UNITED STATES PATENT AND TRADEMARK OFFICE

APPLICATION NO.	FILING DATE	FIRST NAMED INVENTOR	ATTORNEY DOCKET NO.	CONFIRMATION NO.
10/590,335	05/12/2008	Howard Lee Loewenthal	ANDP101US	8371

Office Action Summary	Application No. 10/590,335	Applicant(s) LOEWENTHAL ET AL.	
	Examiner JOHN E. SIMMS JR	Art Unit 3711

DETAILED ACTION

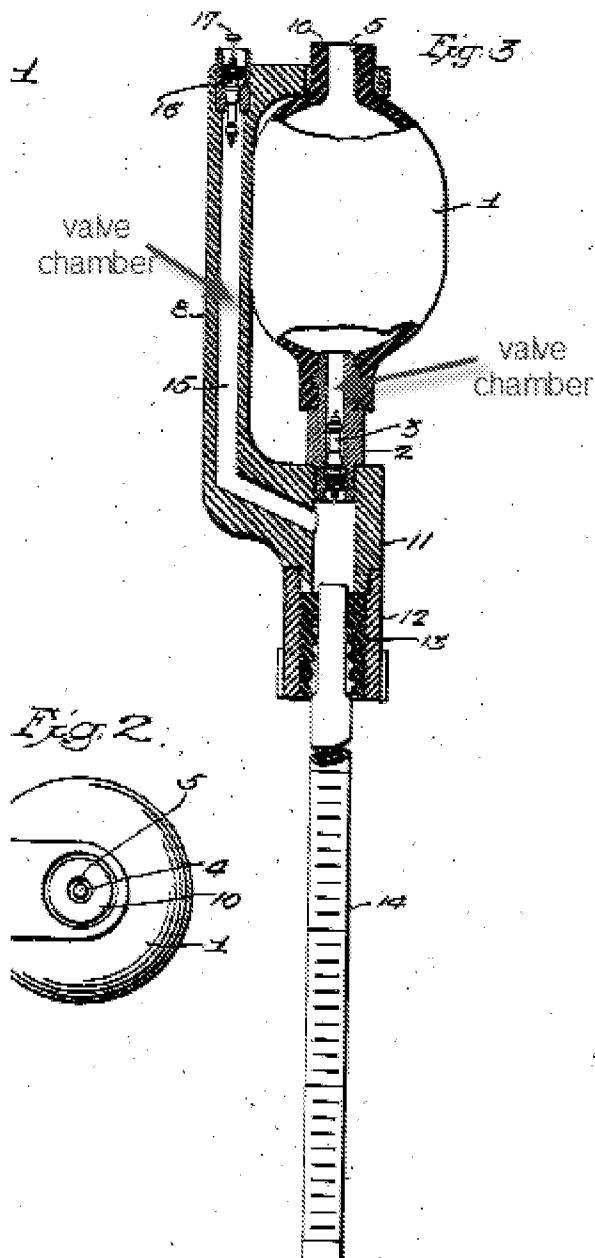
5. As to Claim 2, Caulfield teaches no second valve assembly, see Figure 1, and a valve assembly outer diameter configured to create an interference fit with the inside diameter of a boss (11) on the tube first opening, see Figure 1. Caulfield, as modified, teaches the claimed invention, except for interposing the boss between the valve assembly and the tube first end. It would have been an obvious matter of design choice to form the boss integral with the tube first end, since the applicant has not disclosed that a one-piece design solves any stated problem or is for any particular purpose and it appears that the invention would perform equally well with the boss. As to Claims 3 and 13, Caulfield teaches a device having a first axis parallel to a long axis of a tube (14), when the tube is in a vertical position, see Figure 1, and a second axis at ninety degrees and perpendicular to the first axis, see Figure 1. The examiner notes that the device of Caulfield is capable of being turned to approximately less than ninety degrees without leaking fluid. With particular regard to Claim 13, Caulfield does not show a second valve assembly. As to Claim 4, Caulfield teaches an alternative embodiment of a device having a valve assembly (2, 3, 8, 11, 16), page 1, Col. 1, ln. 50-53, and see Figure 3, and including a first valve chamber with a first opening, in the first valve chamber, and a second valve chamber with a second opening, in the second valve chamber, that operate in opposing directions, page 2, Col. 1, ln. 43-60, and see Figure 3, reproduced below. The examiner notes that to fill the tube (14) expanding air will flow in a first

direction through a first opening or a second opening and expelled air from the bulb (1), to empty fluid will flow in a second direction opposite of the first opening or the opposite of the second opening, page 2, Col. 1, ln. 75 - Col. 2, ln. 4. It would have been obvious to one of ordinary skill in the art, at the time of the invention, to provide Caulfield with the features exhibited in Figure 3, as suggested, to provide first and second chambers with first and second openings, as suggested, to incorporate a valve assembly having first and second valve chambers. Caulfield, as modified, teaches the claimed invention, except for showing the outer surface of the tube (14) forming a seal with the inner surface of the valve assembly, instead of the outer surface of the valve assembly forming a seal with the inner surface of the tube. It would have been an obvious matter of design choice to reverse the male and female aspects of the valve assembly and tube since applicant has not disclosed that the specific choice of fitting the valve assembly into the tube solves any stated problem or is for any particular purpose and it appears that the invention would perform equally well with the tube fitting into the valve assembly, as taught by Caulfield. As to Claim 9, Caulfield teaches a manually closeable vent hole (5), page 2, Col. 1, ln. 1-5. As to Claim 10, Caulfield teaches an elastomeric bulb (1) having a weighted portion of its surface (8), see Figure 1. The examiner notes that the weighted portion would cause the device to rest on the weighted portion (8), when placed on its side. As to Claim 12, Caulfield teaches a leak resistant siphoning device including an elongated hollow tube (14), having a first opening at a first end, a second opening at a second end and an elongated body region between the first end and the second end, and a valve assembly (2, 8, 11), page 1, Col. 1, ln. 50-53, and see Figure 3. Caulfield teaches a second end of the tube having an interior comprising a tapered tubular

surface and a bulb (1), at the second end second opening, see Figure 3. The examiner notes that the valve assembly (2, 8, 11) is configured for connection to the second opening of the second end and the outer diameter of the valve assembly (2, 8, 11) forms a non-fixed seal with the inner diameter of the second end of the tube (14), page 1, Col. 2, ln. 36-37.

Caulfield teaches a first valve chamber and a second valve chamber with a first opening in the first valve chamber and a second opening in the second valve chamber that operate in opposing directions, page 2, Col. 1, ln. 61 – Col. 2, ln. 4. Caulfield teaches the second end of the tube being inserted into the valve assembly instead of the valve assembly being configured for partial insertion in the second end of the tube. The obviousness rationale supporting the reversal of male and female connection, as applied in Claim 4, is considered equally applicable. Caulfield teaches a multi-part valve assembly rather than a one piece molded structure. The obviousness rationale, as applied in the treatment of Claim 6, below, is considered equally applicable. Godfrey is applied as in Claim 1, regarding the absence of metal components. As to Claim 15, Caulfield is applied as in Claim 2.

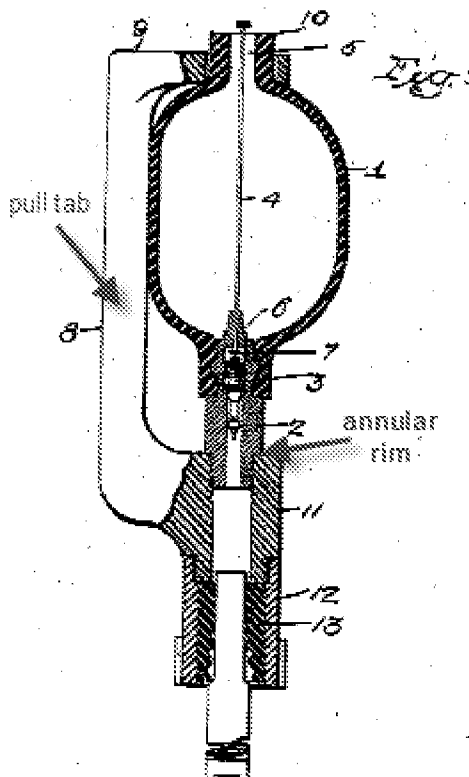
to the inclusion of plastic, silicone, and a polymer. Porter teaches a baster (100) formed using rubber, silicone, or other polymeric materials, Col. 4, ln. 36-37. It would have been obvious to one of ordinary skill in the art, at the time of the invention, to provide Caulfield, as modified, with a valve assembly formed of an elastomer, silicone, and a polymer, as taught by Porter, to provide Caulfield, as modified, with a valve assembly formed of multiple materials, as taught by Porter, to provide Caulfield with a valve assembly formed of specifically selected materials to yield the predictable result of providing a suitable structure at a minimum cost. Caulfield, as modified, teaches the claimed invention, except for indicating the use of plastic, in the valve assembly. Suter teaches a juice extractor (50) having a valve assembly formed of plastic, Col. 11, ln. 40-42. It would have been obvious to one of ordinary skill in the art, at the time of the invention, to incorporate plastic material into the valve assembly, as taught by Suter, to provide Caulfield, as modified, with an additional material forming the valve assembly, to yield the predictable result of providing a valve assembly incorporating the most advantageous composition. With particular regard to Claim 14, Porter teaches a valve assembly excluding metals. It would have been obvious to one of ordinary skill in the art, at the time of the invention, to provide Caulfield, as modified, with a valve assembly having no metals, as taught by Porter, to provide Caulfield, as modified, with a non-metal construction, to yield the predictable result of reducing costs. As to Claim 6, Caulfield teaches a single valve opening/slit in the valve assembly, see Figure 1, the valve assembly having an annular rim, which limits insertion of the valve assembly into a boss (11) which forms a seal with the tube (14) and a pull tab (8) configured to allow the valve assembly to be removed from the tube (14), see reproduced Figure 1, below. Caulfield, as modified, teaches the claimed invention, except for teaching the

valve assembly being inserted into the boss, which is sealed with the tube instead of showing the valve assembly inserted directly into the tube. It would have been obvious to one having ordinary skill in the art at the time the invention was made to construct the boss to be integral with the valve assembly, since it has been held that use of one piece construction instead of rigidly secured parts is an obvious matter of engineering choice, *In re Larson*, 340 F. 2d 965, 968, 144 USPQ 347, 349 (CCPA 1965).
